**Olive Downs Coking Coal Project**

Additional Information to the  
Environmental Impact Statement

**Transport**

## 16 TRANSPORT

Figure 16-1

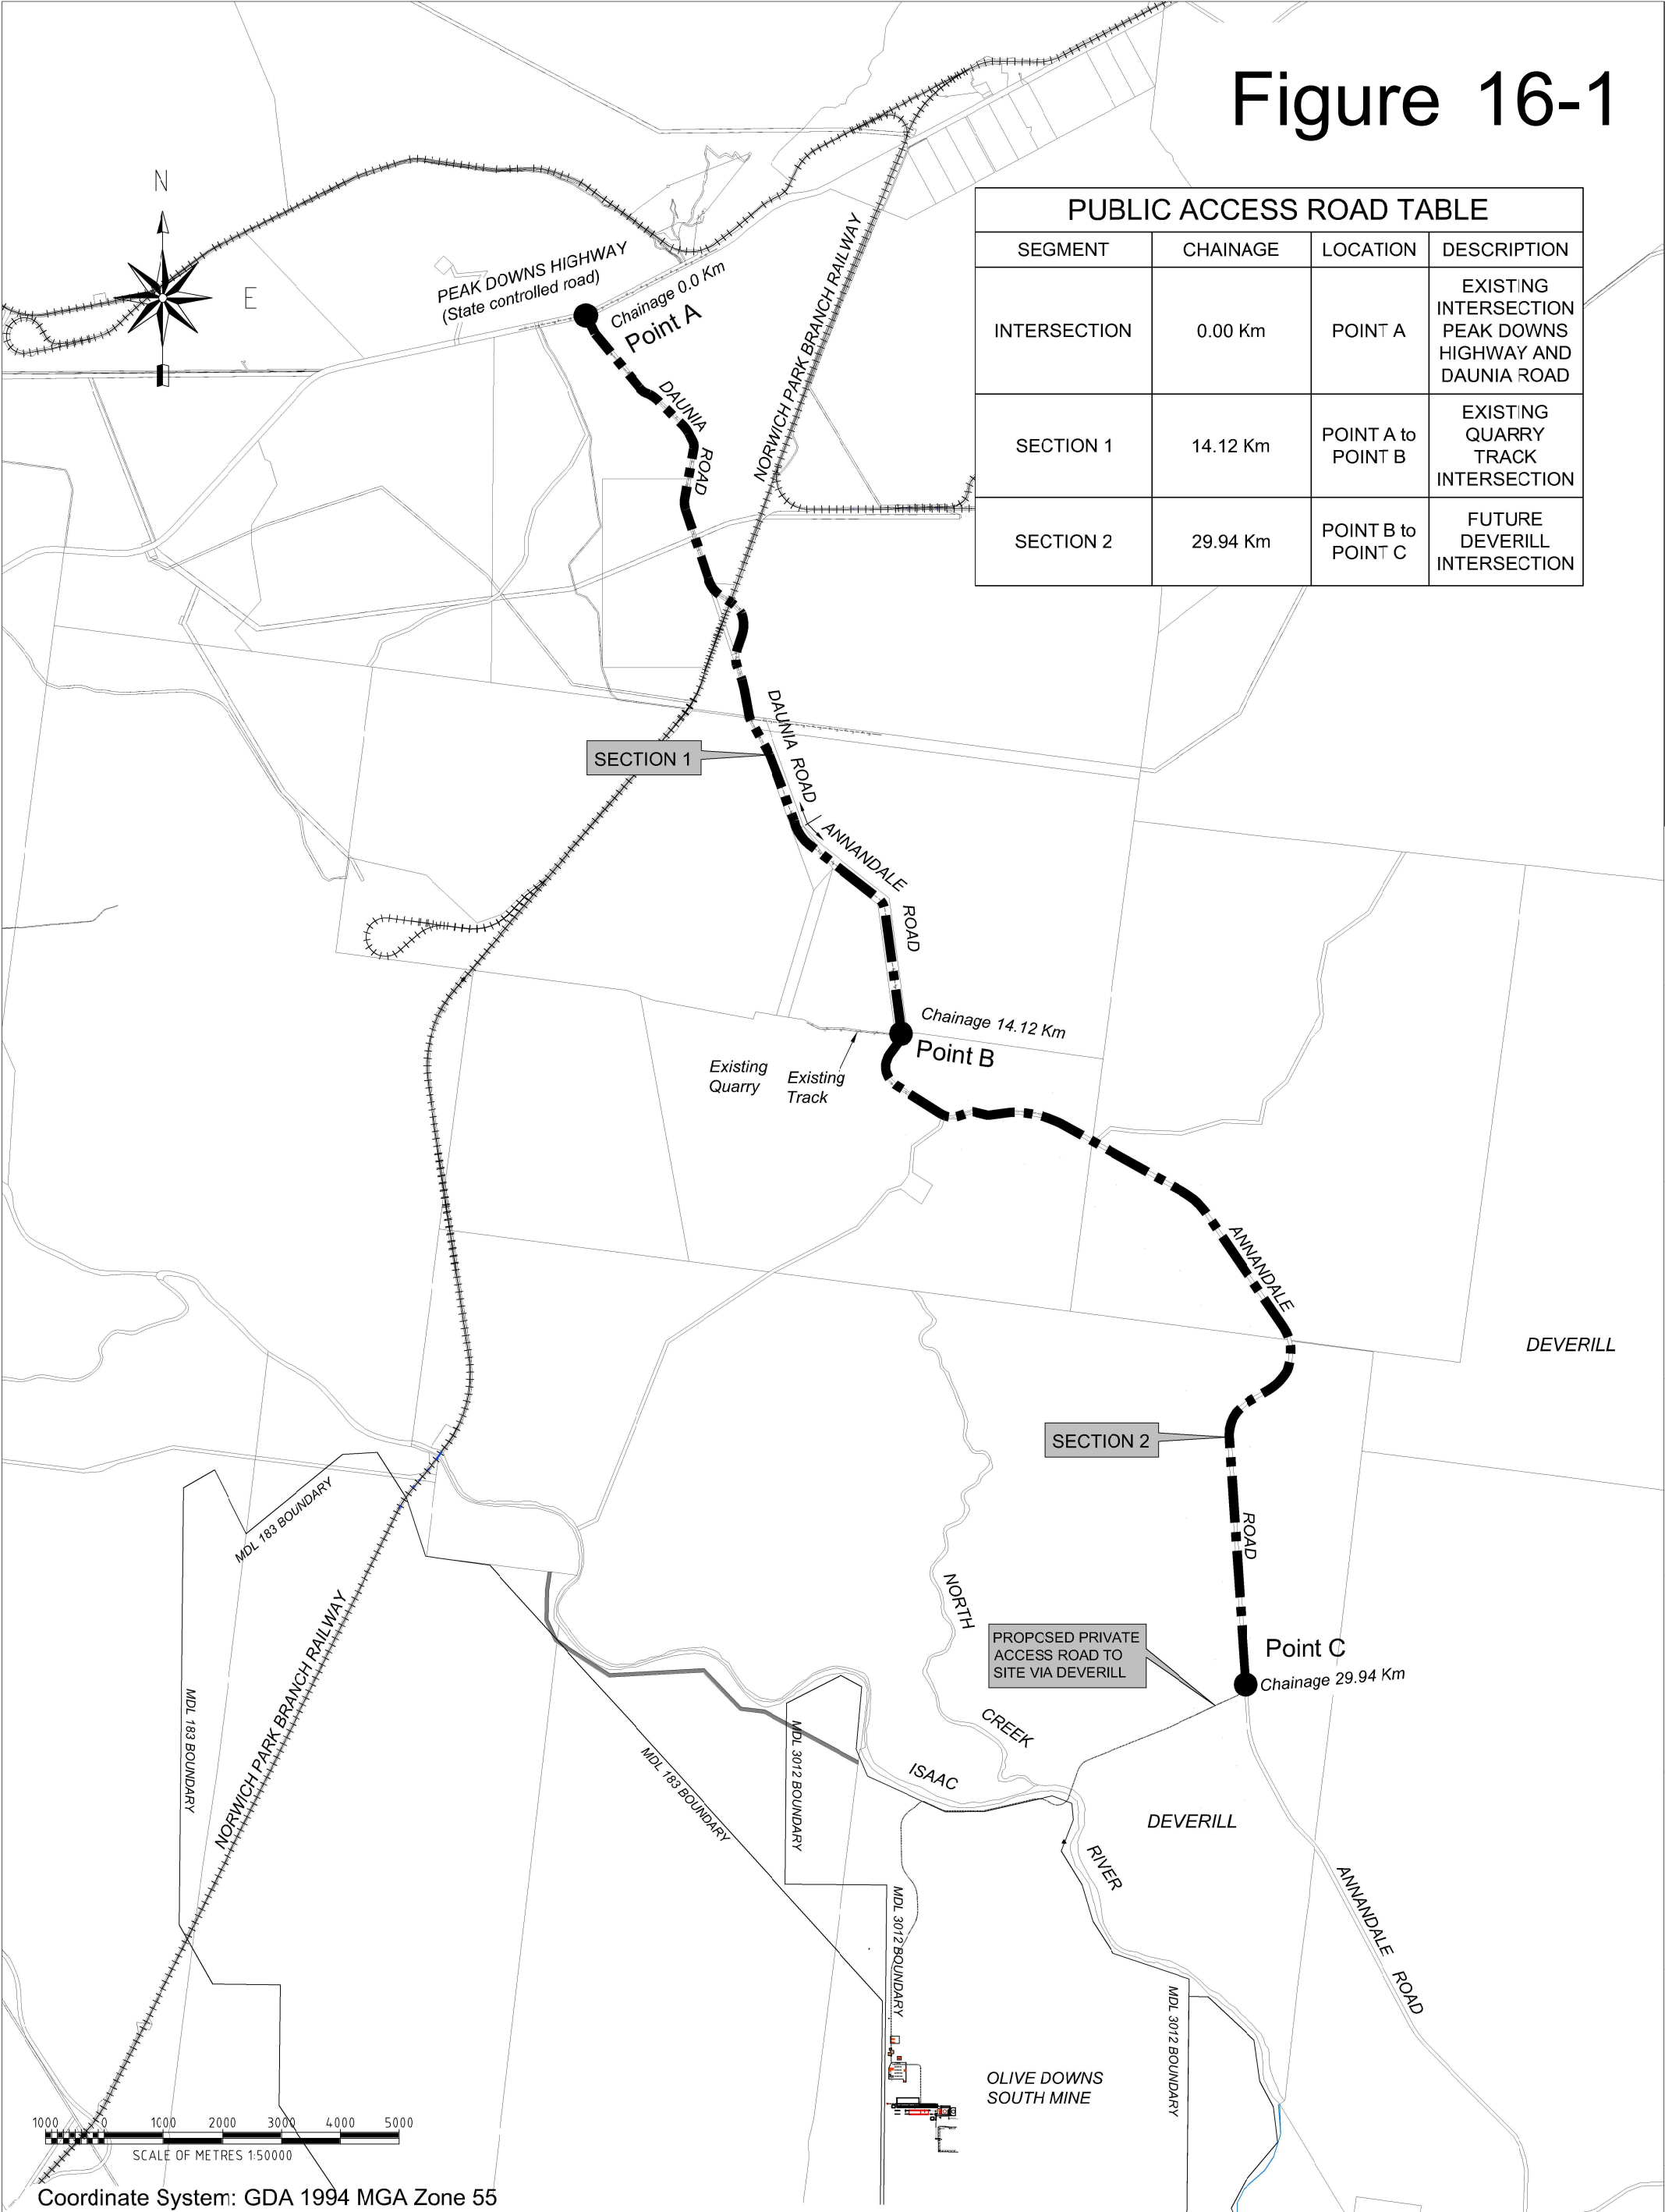
- 1. Provide further information on the proposed upgrades of Daunia and Annandale Roads, including maps, detailing the location and details of upgrades proposed, and clarity on the proponent's position regarding the responsibilities for undertaking and financing the road works.***

At the time of writing, the IRC has engaged Projex Partners to undertake detailed designs for first 21 km of proposed upgrades. The proposed Daunia and Annandale Road upgrades have been designed with the following parameters:

- design speed of 110 km/h;
- 1% AEP flood immunity;
- 10 m wide sealed road comprising two 4 m wide traffic lanes with 1 m wide shoulders;
- pavement life of 20 years;
- certain sections of road will be realigned to accommodate the proposed design speed; and
- the road will be fully fenced on both sides to prevent stock entering.

Conceptual road upgrade designs developed by Projex Partners, and provided to the IRC, are shown on Figures 16-1 and 16-2.

Figure 16-3

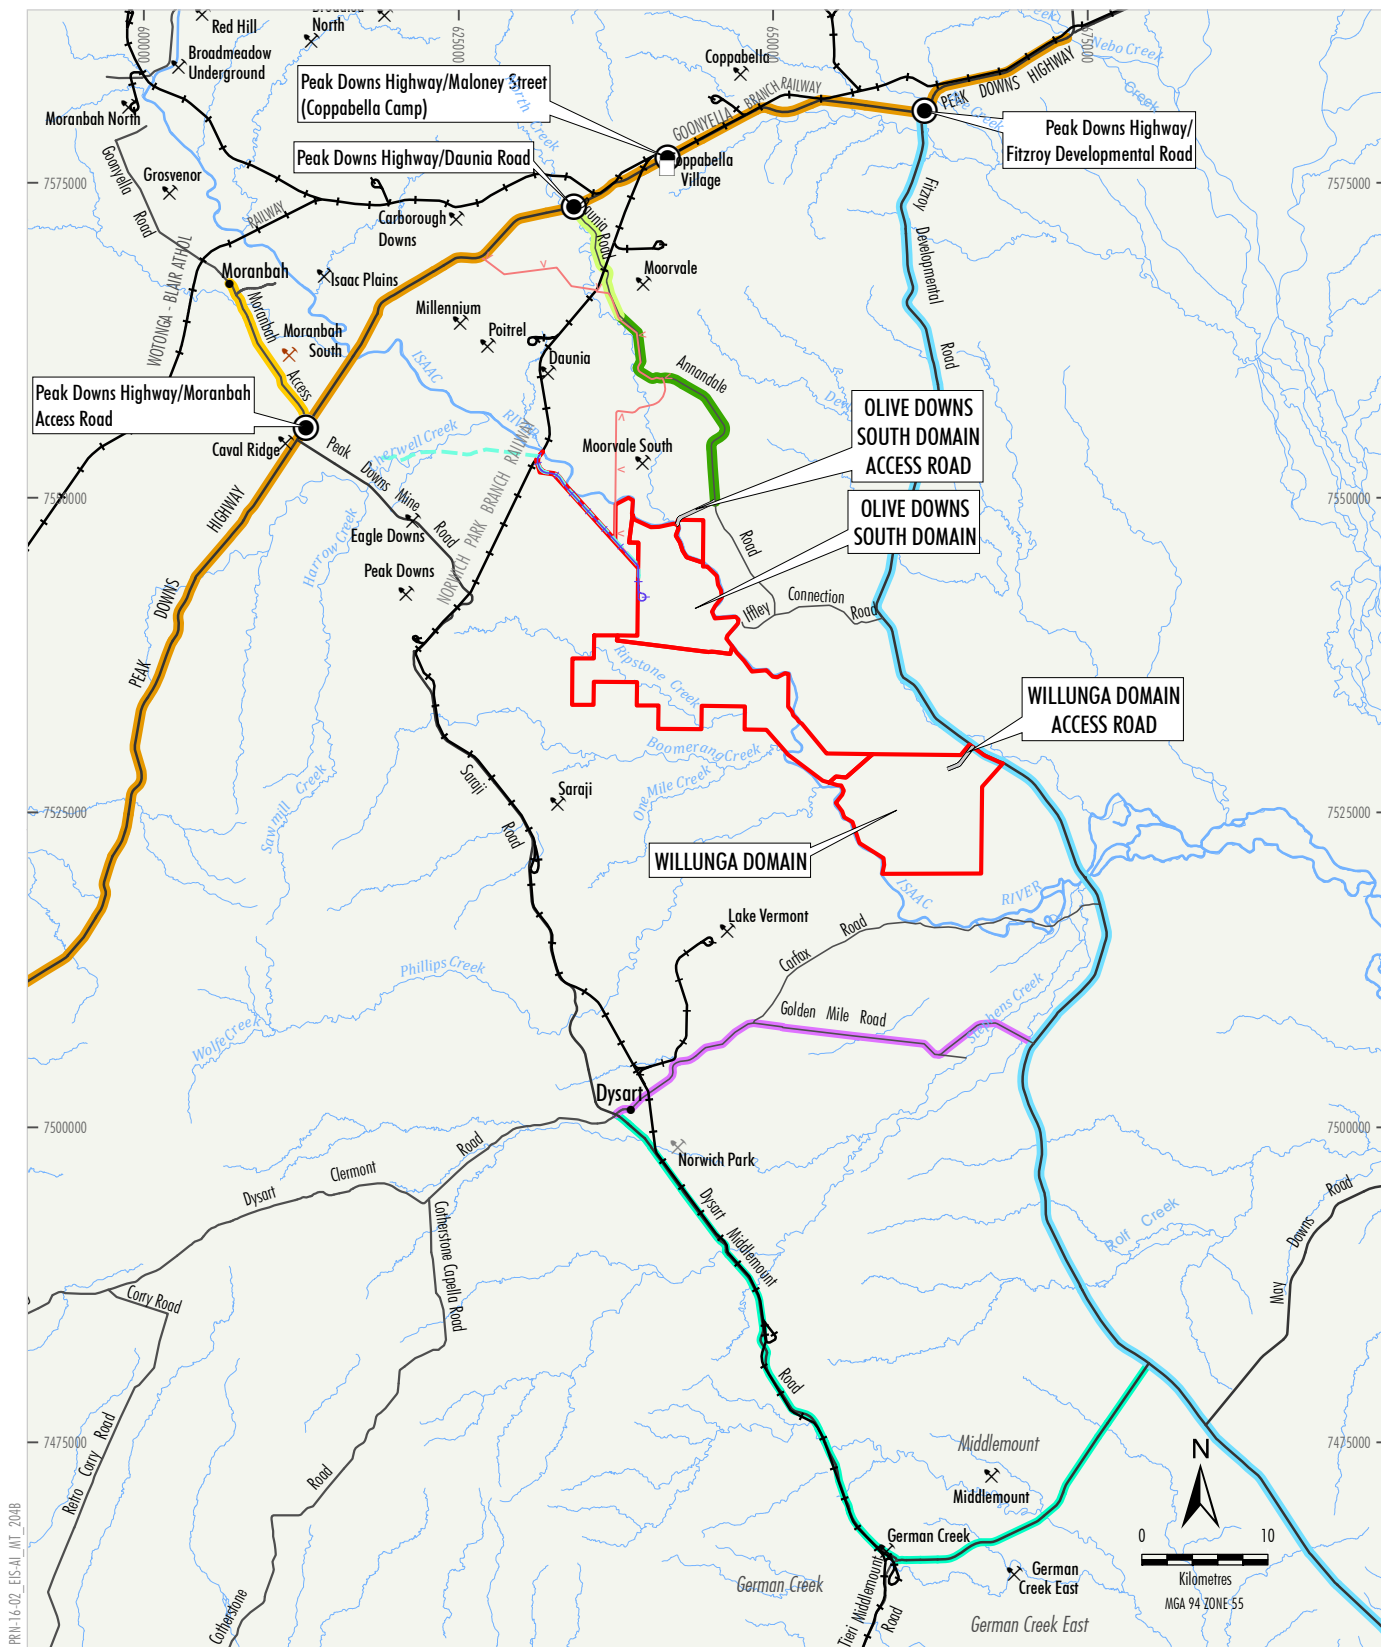
- 2. Clarify the expected volume of traffic travelling to the site from the south and the impact of this traffic on affected roads (e.g. roads from Dysart/Middlemount).***

**3. Provide an assessment of traffic impacts on Annandale Road (south of the proposed Olive Downs South Access Road), Iffley Connection Road and Vermont Park Road, considering IRC's advice that these roads are expected to be impacted by DIDO traffic.**

**4. Provide traffic modelling and an assessment of intersection performance under modelled scenarios for those intersections raised in the IRC submission (Carfax Rd/Golden Mile Rd, Carfax Rd/Fitzroy Developmental Rd, Fitzroy Developmental Rd/Iffley Connection Rd, Iffley Connection Rd/Annandale Rd).**

For those personnel travelling from Middlemount and Dysart, it is expected that the following roads would be utilised (Figure 16-3):

- Dysart Middlemount Road (for traffic travelling from Middlemount [i.e. 87 when the Project workforce reaches its maximum]);
- Golden Mile Road (for traffic travelling from Dysart [i.e. 151 persons when the Project workforce reaches its maximum]); and
- Fitzroy Developmental Road (for traffic travelling from Middlemount and Dysart [i.e. 238 persons when the Project workforce reaches its maximum]).

As shown on Figure 16-3, Pembroke does not propose to utilise Annandale Road (south of the proposed Olive Downs South access road), Iffley Connection Road or Vermont Park Road for any Project related traffic.

As outlined in response to Item 3 above, Pembroke does not propose to utilise Iffley Connection Road for any Project related traffic (Figure 16-3). As such, anticipated traffic using the Fitzroy Developmental Road/Iffley Connection Road and Iffley Connection Road/Annandale Road intersections would only be related to through traffic (i.e. no Project traffic would be turning at these intersections).

Similarly, with respect to the intersections along Carfax Road, Project traffic would be limited to through traffic as Pembroke does not propose to utilise Carfax Road for any Project related traffic (Figure 16-3). Carfax Road (an unsealed road) is approximately the same length as Golden Mile Road (along the route to the Project from Dysart), however, as Golden Mile Road is sealed, anyone travelling along this route is expected to use Golden Mile Road as it would allow for safer, more efficient travel compared to Carfax Road.
